Perce Certification Plan
RE: Cashmark Property
John's Hopkins Road

RE: Percolation Test Results
Application Numbers: A49709 and A49708
Proposed Use: Subdivision
Property ID: Cashmark - Lots 1 & 2
Johns' Hopkins Road-Sanner Road

Needs Wet Season Data @ 59, 5J
PERC CERTIFICATION PLAN.
PROPERTY OF
JOHN S. CASHMARK, et al.

**CASHMARK PROPERTY, LOT 2
(PLAT 12405)**

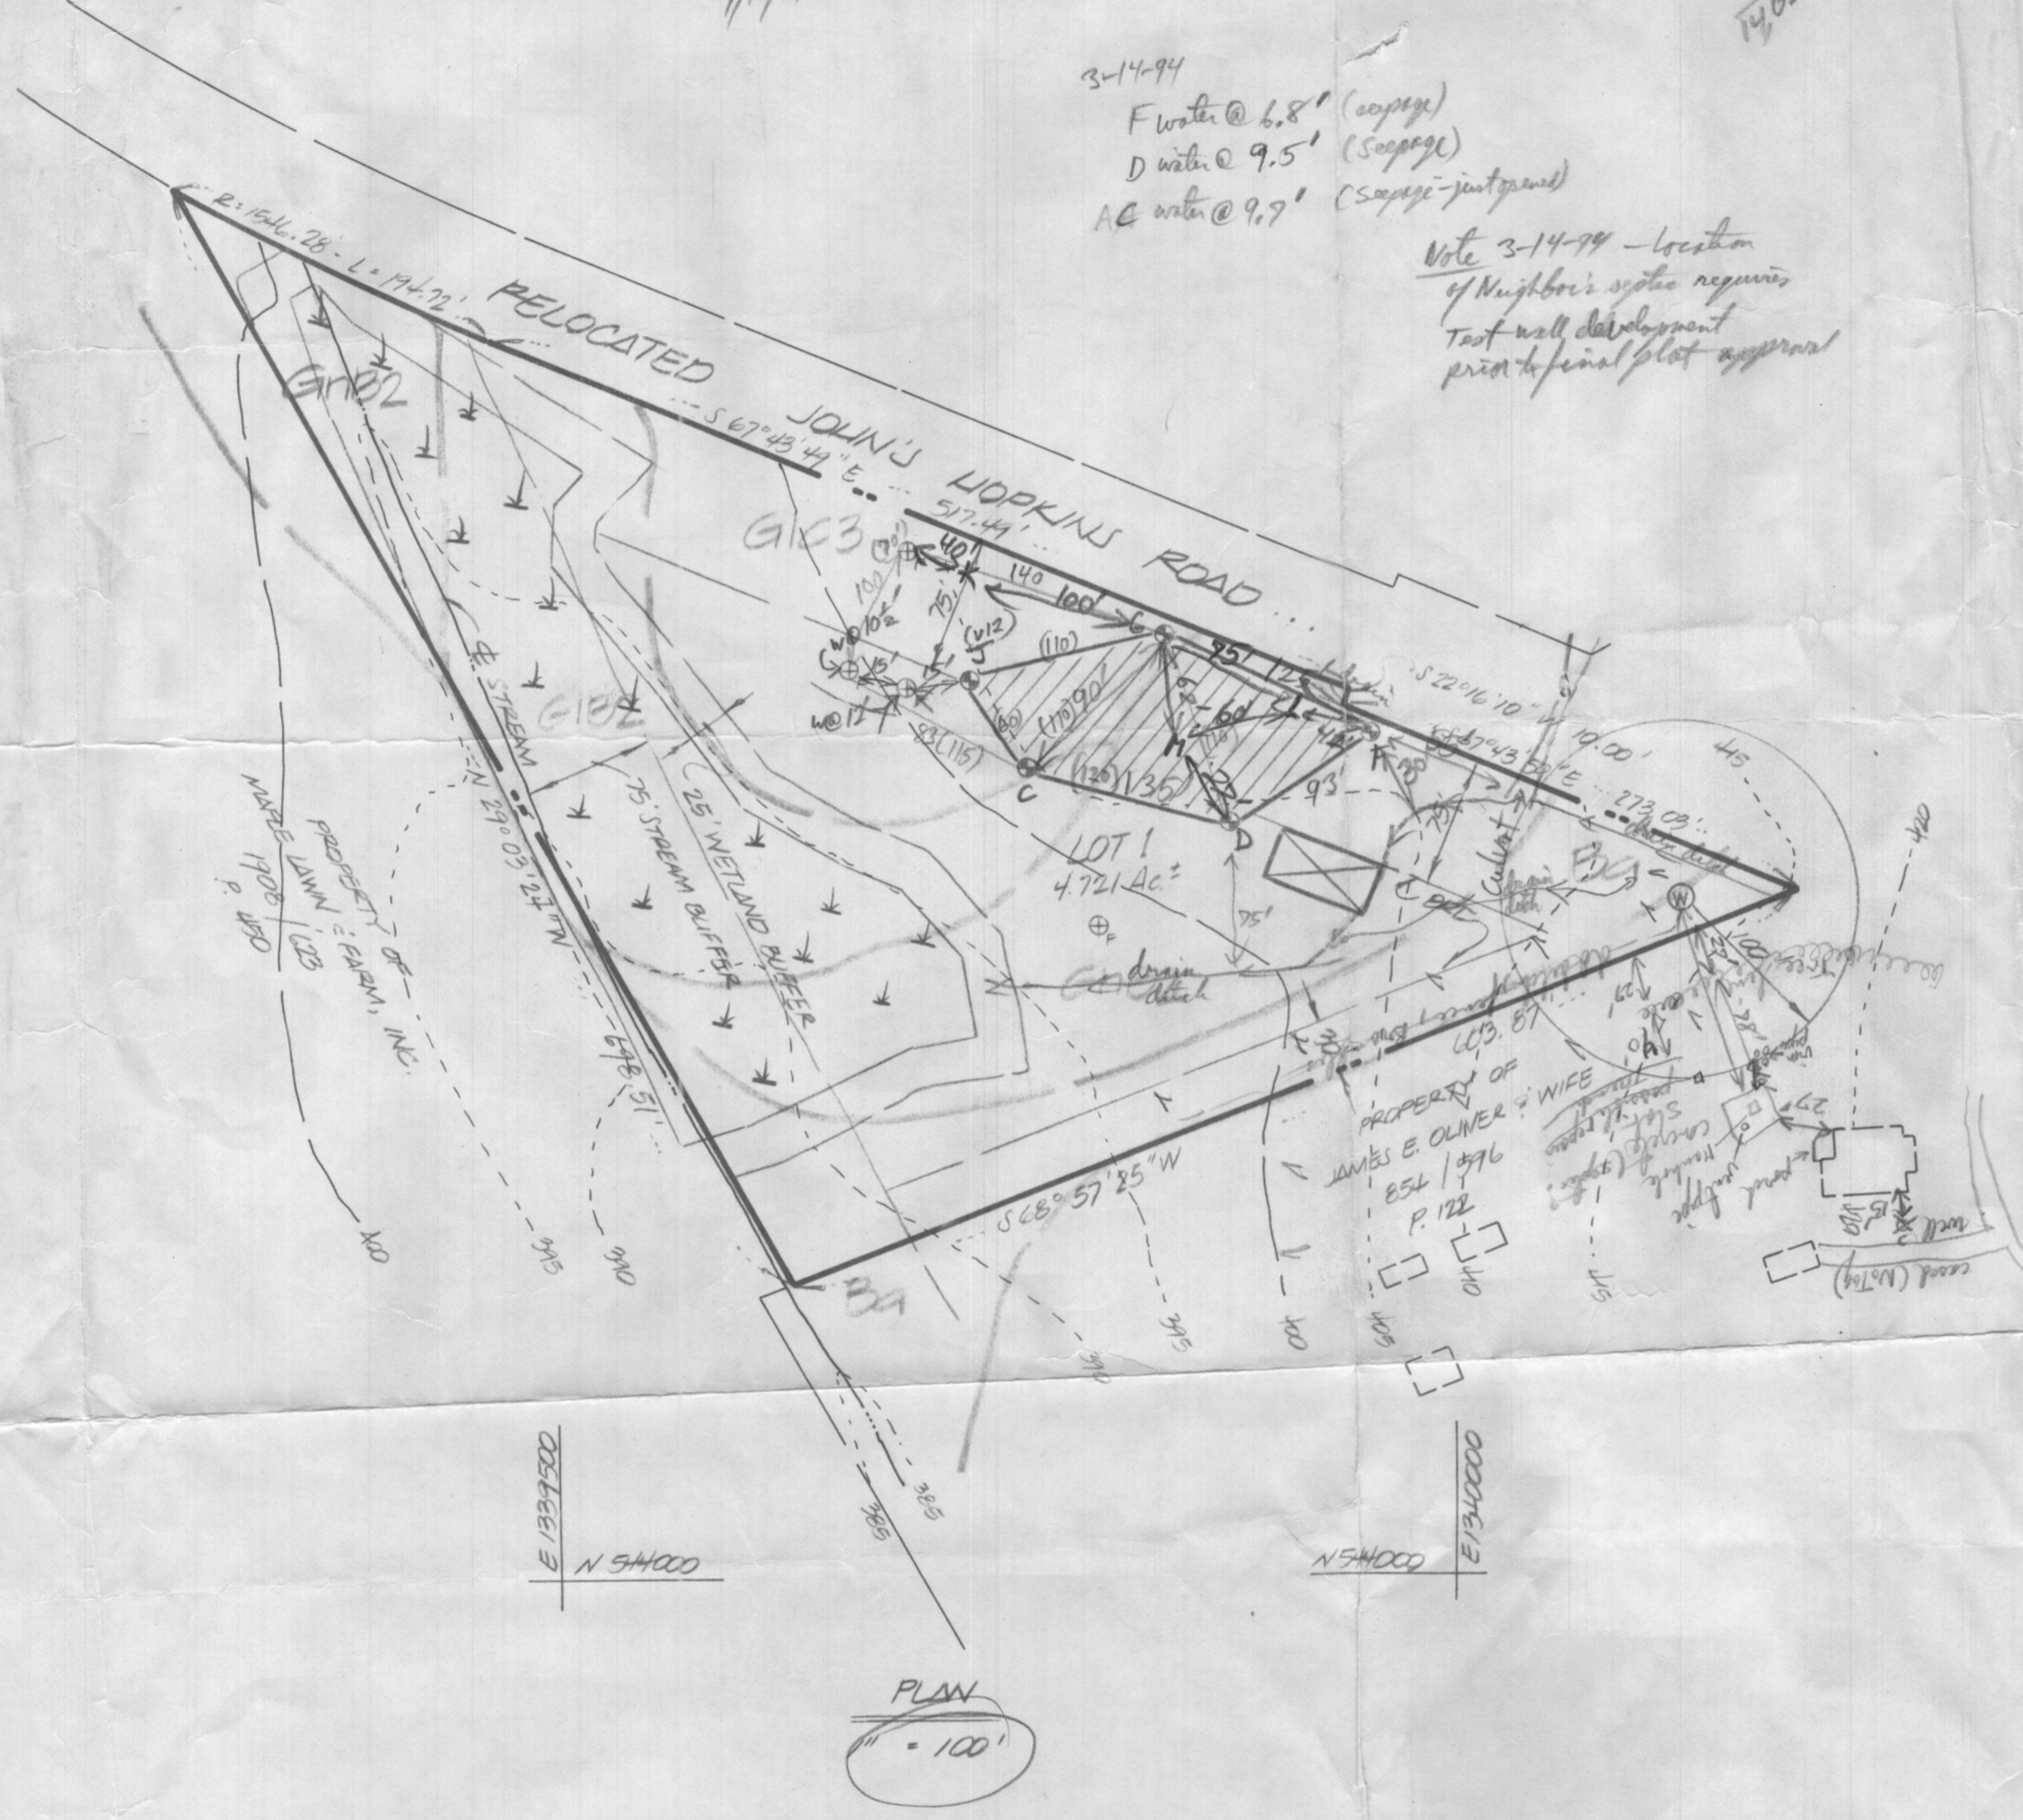
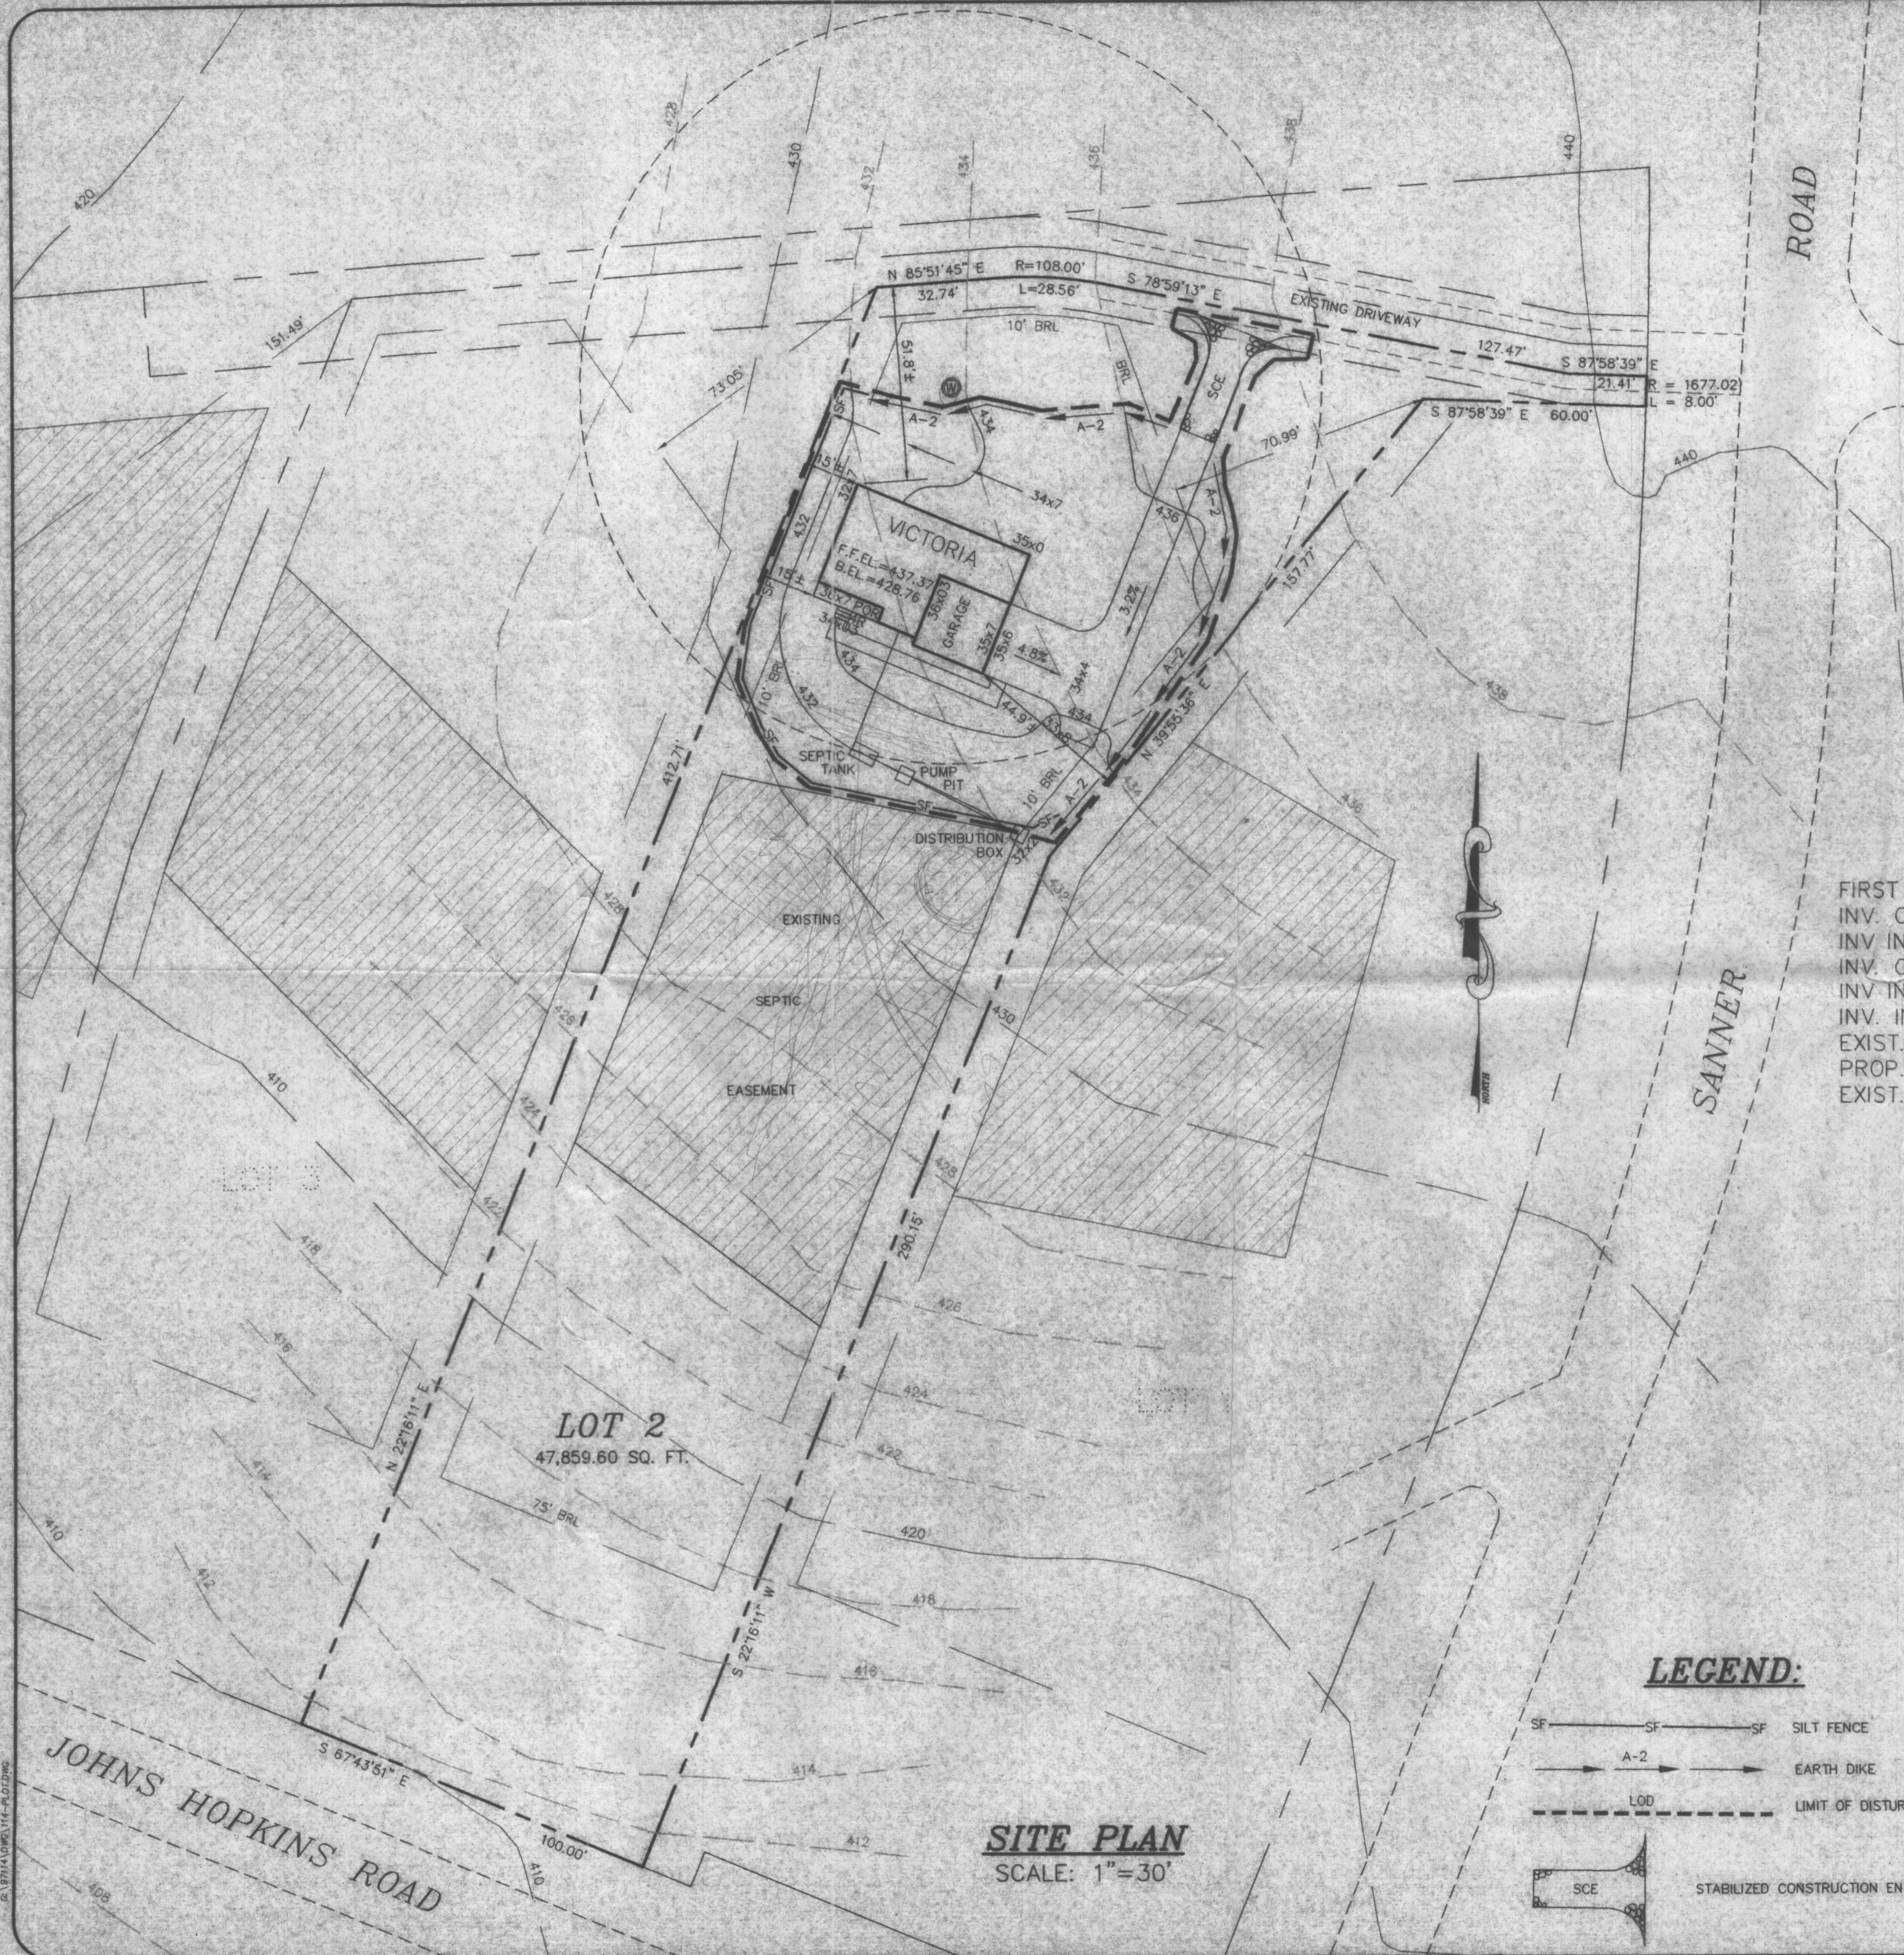
I've reviewed the proposed Perce Certification Plan for the above referenced property. Although originally offered as 2 lot tract, it is now currently proposed as a single lot with the designated sewage disposal area effectively on the highest part of the lot. As a result there are several potential problems which must be resolved prior to any further consideration may be given to this property.

First, our letters of October 29 and December 21, 1993 both refer to the need for confirming water table tests during the Spring wet season. That season is now here and we have not yet received a request to schedule these tests. Please do so as soon as possible.

An adequate well site remains in question because of incomplete information on septic systems and wells on surrounding properties. In addition to ~~the~~ existing wells and septic within 200 ft of the property line, there is a pending proposal for a nearby shared septic area which may severely restrict alternative well site location.

Finally, the well site, as proposed in this plan, is situated in a narrow corner of the lot and in what appears to be a drainage swale according to the elevation contours submitted. Such a well site location is less than ideal and may just prove "unacceptable" pending collection of septic information on adjacent properties as discussed above. At the very least, well development and testing prior to final plan approval would be required.

9/19/94 - Trade Not Done yet

3-14-94
F width @ 6.8' (Sagepage)
D width @ 9.5' (Sagepage)
AC width @ 9.7' (Sagepage - just grass)

Note 3-14-94 - location of Neighbor's system requires that well development prior to final plot approval
